Adequacy of Management Plans for the Future Generation of Spent Nuclear Fuel and High-Level Radioactive Waste

A Report to the President
and the Congress
in Accordance
with Section 803
of the Energy Policy Act of 1992

PREDECISIONAL DRAFT
OCTOBER 8, 1993

Figure 3-1
Amount of Spent Nuclear Fuel Discharged Annually by the
No-New-Orders Case and the Upper Reference Case

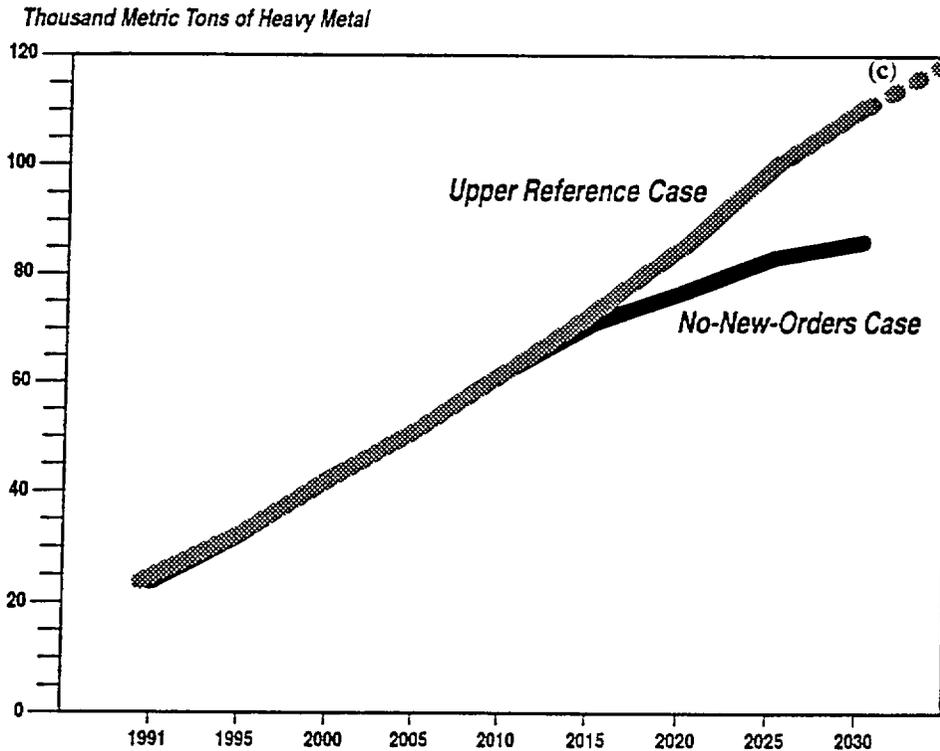
- We revised Figures 3.1 and 3.2 to indicate that waste production for the upper reference case will extend beyond 2030.
- We estimate, in section 7, the amount of spent fuel that would be generated by 2030 as a result of the Department ending reprocessing.
- We revised section 3.3 to define which provisions of the Energy Policy Act would contribute to the resurgence of the nuclear power industry.

Figure 6-1
Spent nuclear fuel and high-level radioactive waste generated by three scenarios through 2030.

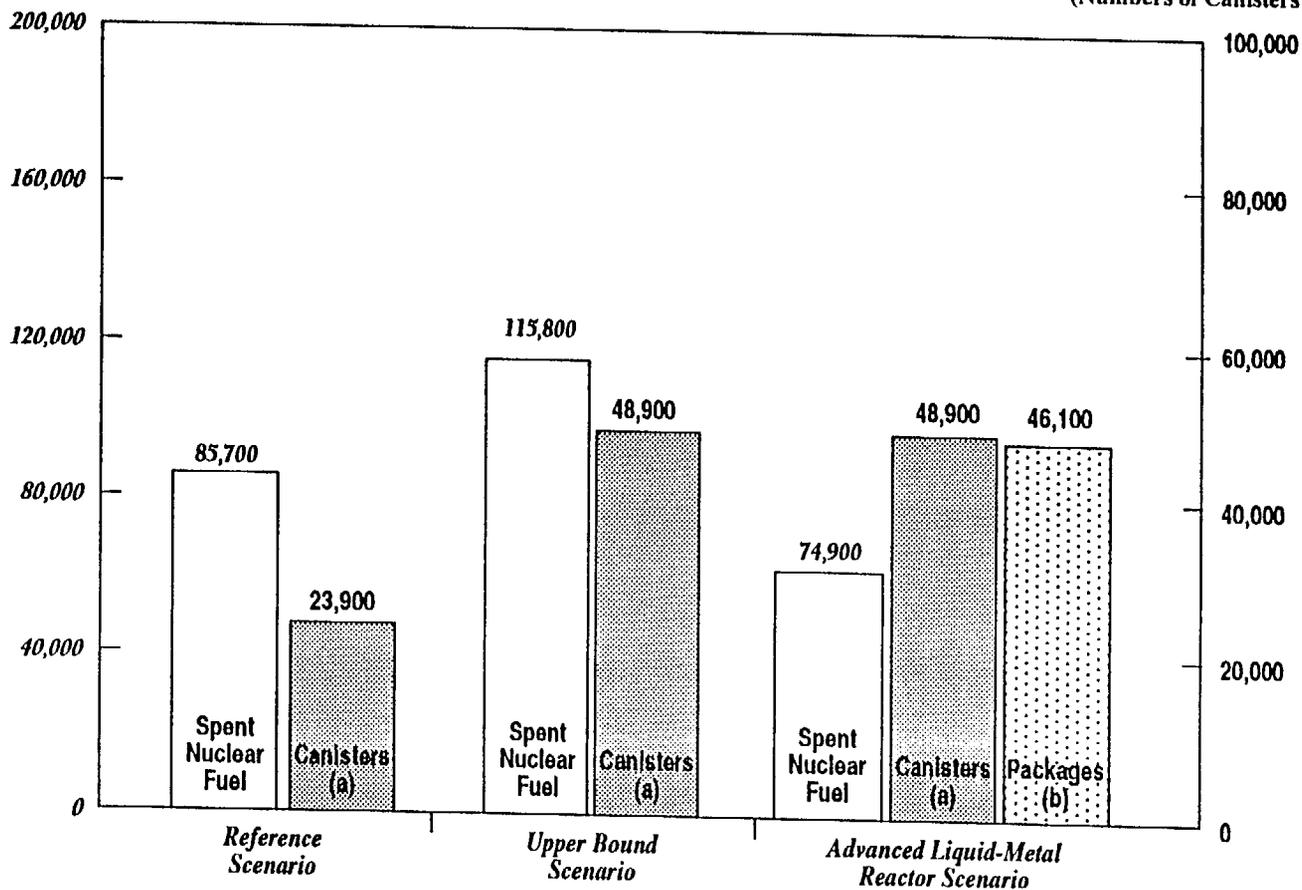
Table 6-1 and Figure 6-1 are misleading. The total waste packages are shown in the ALMR Scenario but are not shown for the Reference and Upper-Bound Scenarios. This indicates a
